ADDENDUM NO. ONE (1)

APRON EXPANSION

**CHARLOTTESVILLE-ALBEMARLE AIRPORT
CHARLOTTESVILLE**

JUNE 11, 2019

EXPAND TERMINAL APRON	AIP NO. 3-51-0004-047-2018		JOB NO. 17018
GRADING & DRAINAGE PLAN CONCRETE APRON	DRAWN BY: LAA		SHEET C135-2
	DESIGNED BY: KMJ		
CHARLOTTESVILLE-ALBEMARLE AIRPORT	SCALE: 1" = 20'	DATE: MAY 2019

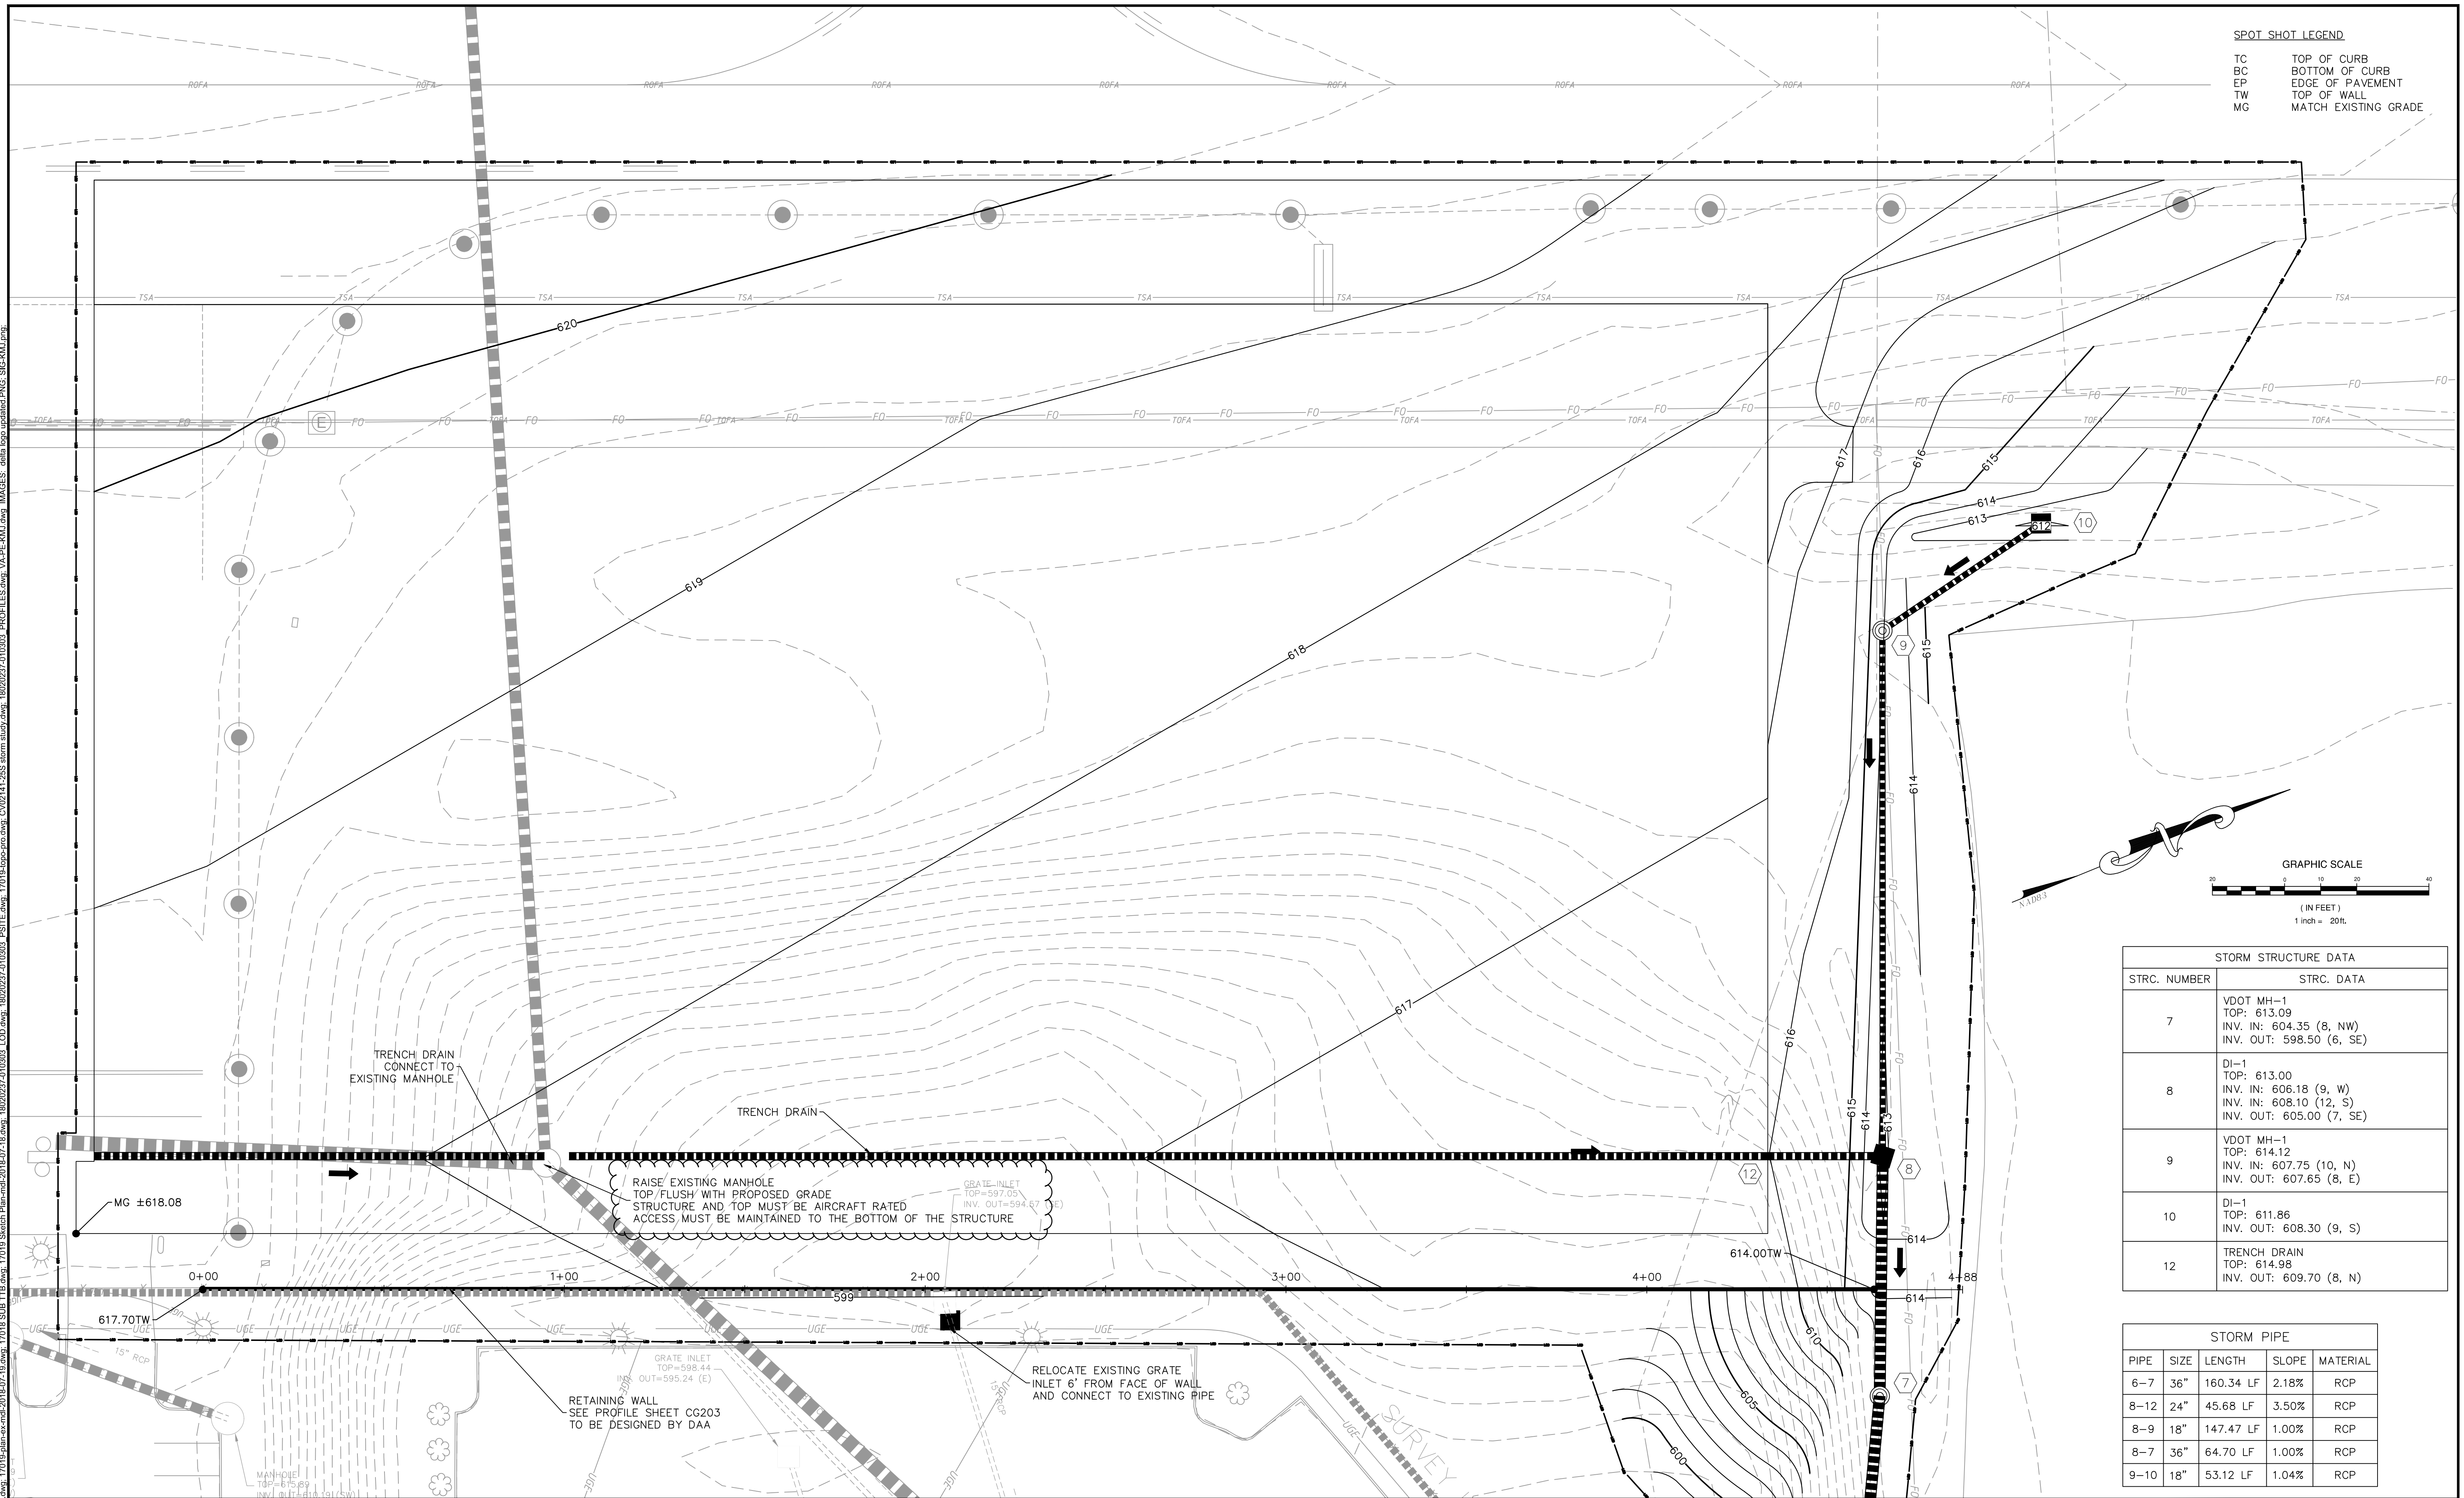
5. **REPLACE** Sheet C135-2 Grading & Drainage Plan Concrete Apron with Revised Sheet C135-2.
6. **ADD** Sheet C202-2 Retaining Wall Profile.
7. **REPLACE** Sheet C503-2 Drainage Details with the Revised Sheet C503-2.

6. QUESTION: Plan C135-2 refers to a retaining wall profile by Draper Aden (CG203). Is this profile plan available?

7. QUESTION: Plan C503-2 has the trench drain detail marked as “NIC”. For trench drain shown on Plan C135-2, is info such as manufacturer/model, invert elevations and details provided elsewhere?

13. QUESTION: Will apron drainage be handled with slot drains or a trench drain?

ANSWER: The profile has been added and is shown on Sheet C202-2.

ANSWER: The apron will be drained using a trench drain. Payment will be made under Item D-702 for 8” trench drain. See the detail on the revised Sheet C503-2 Drainage Details.

EXPAND TERMINAL APRON	AIP NO. 3-51-0004-047-2018		JOB NO. 17018
DRAINAGE DETAILS	DRAWN BY: LAA		SHEET C503-2
	DESIGNED BY: KMJ		
CHARLOTTESVILLE-ALBEMARLE AIRPORT	SCALE: NONE	DATE: MAY 2019

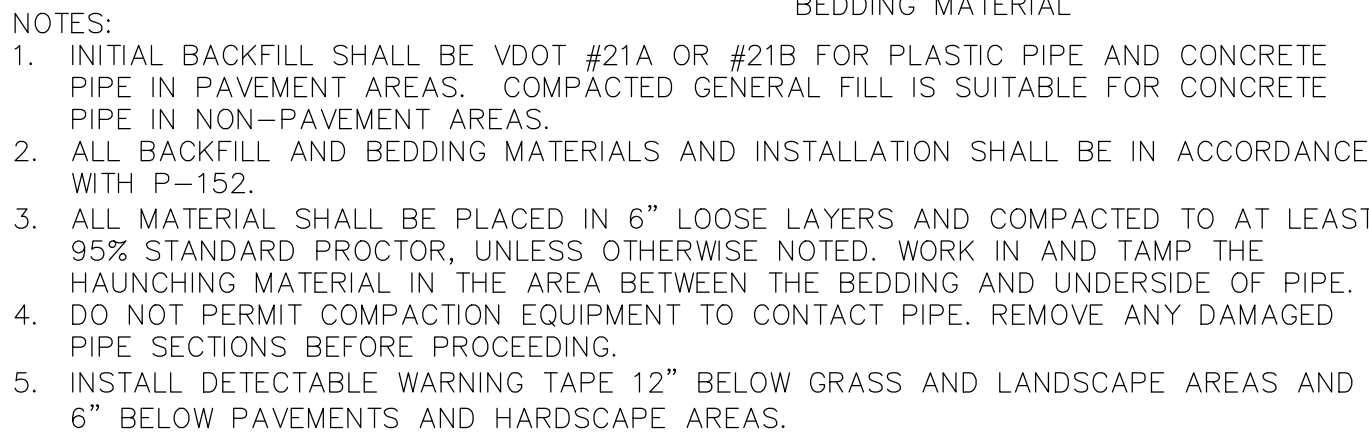
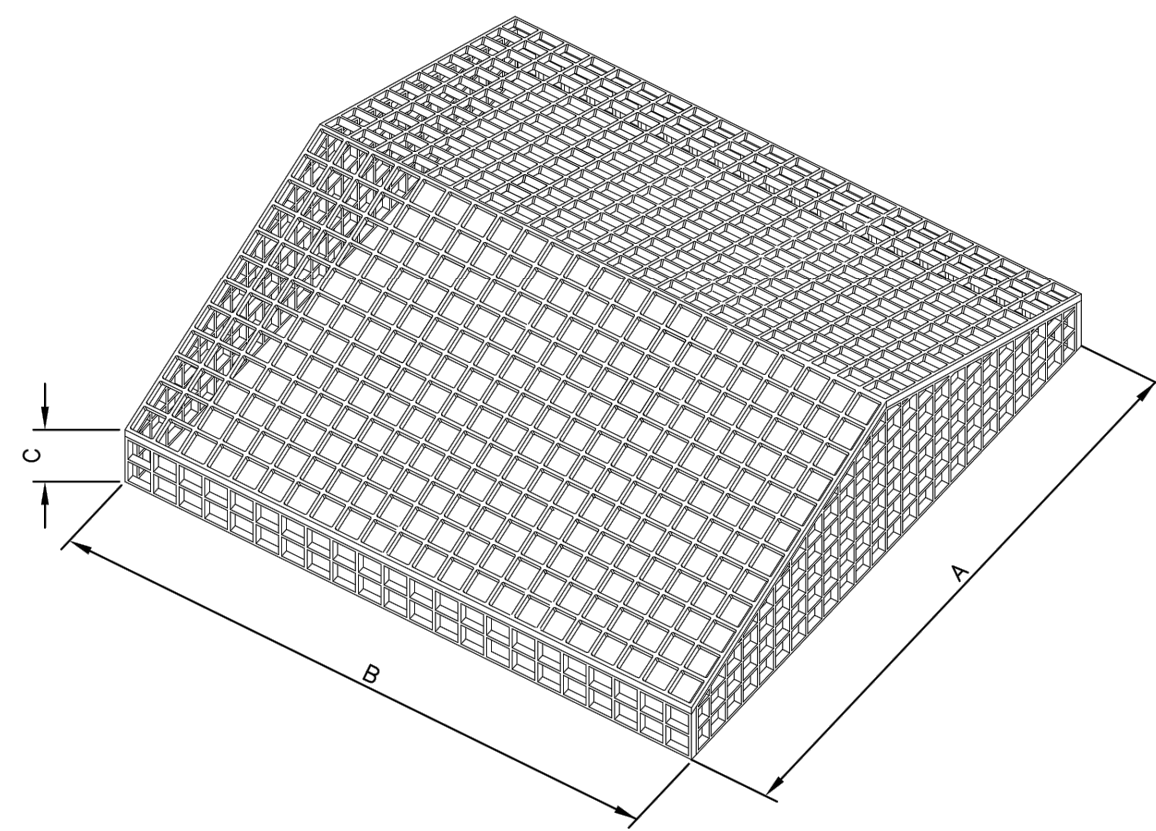
10. QUESTION: Is there a detail for the proposed Trench Drain?

ANSWER: Sheet C503-2 has been revised and reissued.

ANSWER: See revised Sheet C503-2

EXPAND TERMINAL APRON	AIP NO. 3-51-0004-047-2018	JOB NO. 17018
APRON PARKING LOT NEW WORK PLAN	DRAWN BY: CMD	SHEET
CHARLOTTESVILLE ALBEMARLE AIRPORT	DESIGNED BY: CMD	E102-3
	SCALE: 1" = 30'	DATE: MAY 2019

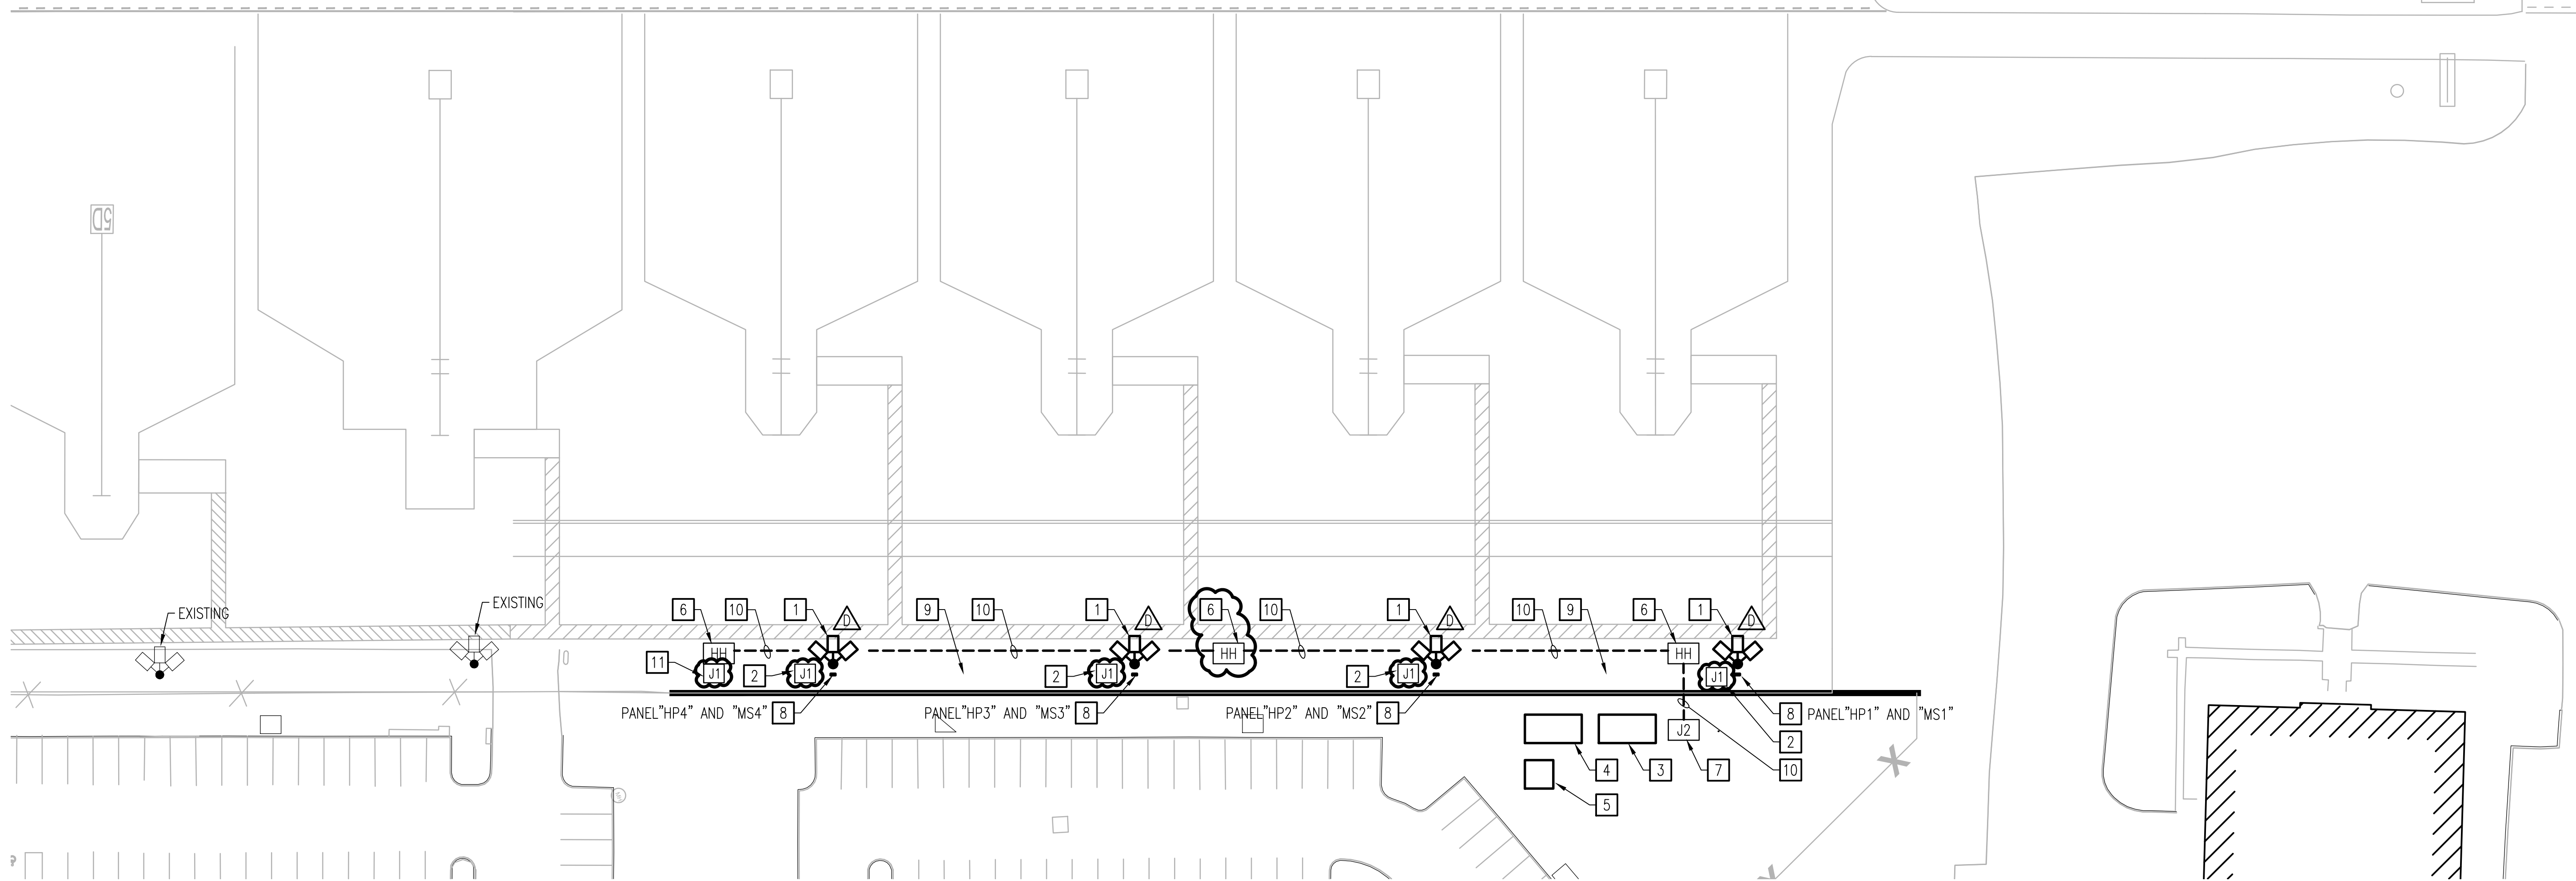
9. **REPLACE** Sheet E001-3 General Notes, Legend and Abbreviations with the Revised Sheet E001-3.
10. **REPLACE** Sheet E102-3 Apron Parking Lot New Work Plan with the Revised Sheet E102-3.
11. **REPLACE** Sheet E501-3 Details with the Revised Sheet E501-3.
12. **REPLACE** Sheet E601-3 Schedules and Diagrams with the Revised Sheet E601-3.
13. **REPLACE** Sheet E602-3 Power Riser Diagram with the Revised Sheet E602-3.
